CONSERVATION TEAM CONSULTATION APPLICATION RESPONSE

APPLICATION REF:	26/00102/FP
CASE OFFICER:	HT
APPLICATION SITE:	Land adjoining Cantlebury Chapel Street and 1 Christys Yard, Hinxworth, Hertfordshire SG7 5EH
DESCRIPTION OF WORKS:	Minor revision of the previously approved scheme ref.24/02404/FP - Erection of one detached 2-bed bungalow with associated access, car parking, private garden and landscaping (with refined proportions, minor dimensional adjustments, and revised fenestration). No change of use is proposed.

The building granted planning permission measures 6000 x 12000 (see below).

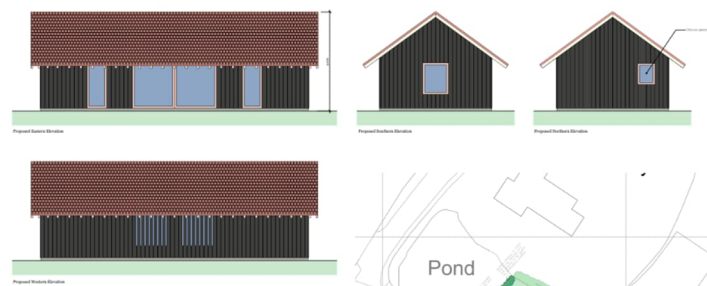
There is no doubting in my mind that the slightly wider yet more compact built form of the granted scheme is considered more positively when compared with the latest iteration and has a stronger outbuilding aesthetic. The question is, do these latest changes go far enough in addressing heritage-based concerns raised at pre-app?

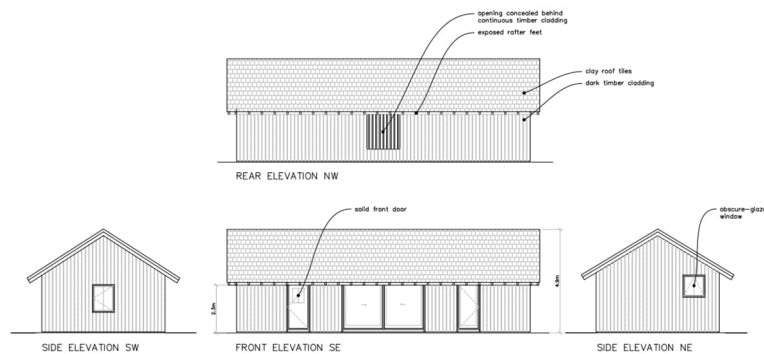
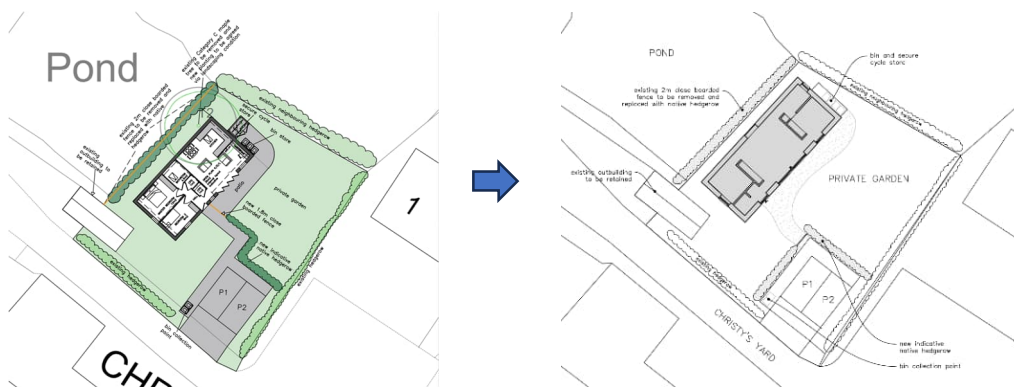
The case officer concluded that *“the principle of a bungalow dwelling within this location is supported under Policy SP2 and CGB1, but the broad design would not be considered acceptable and **would harm the neighbouring heritage assets**”*. The scheme below is broadly similar to that at pre-app but I note:

- Less accentuated over-hanging eaves
- Solid front door
- Smaller window on SW elevation
- Single window to rear NW elevation

Normally, I would not raise a specific issue regarding overhanging verge details but here the additional footprint length means that any projecting verge exacerbates the perception of length. Either the roof verge should be like that below or the footprint reduced.

I had not previously mentioned the vertical boarding. A more successful scheme would be dark-stained traditional horizontal boarding as found elsewhere in the conservation area and as formed part of the granted scheme.

The granted scheme has a roof pitch of 35° which, on reflection, is unlikely to be sufficient to accommodate clay handmade tiles (normally 40°) even though that is what the application suggested and what is covered by Condition 3 part i. The current proposal sees the roof pitch slackened to 32° which is not only unlikely to be acceptable for clay handmade tiles but may not be sufficient even for machine made tiles. The gable width has been reduced by 300mm which should allow for the roof pitch to be raised from 35° without a significant rise in overall height and to the point of hopefully being able to take a handmade clay tile roof.

Whilst noting that the right-hand bedroom has no window and is reliant upon natural light from the door I suggest that either i) the door is a solid door (if required as alternative means of escape) and a small conservation roof light added at this end or ii) the door becomes more solid with a slatted appearance (below left and would echo the window on the rear NW elevation), or iii) part-glazed (below centre) or iv) a stable-type (below right). In either case, the timber being dark painted or stained to compliment hopefully dark-stained horizontal boarding and the left-hand entrance door.

Finally, the submitted DAS refers to 'light oak-toned' timber windows and doors. In my opinion, it would be better if the external joinery was similar to the dark-stained boarding rather than 'standing out'.
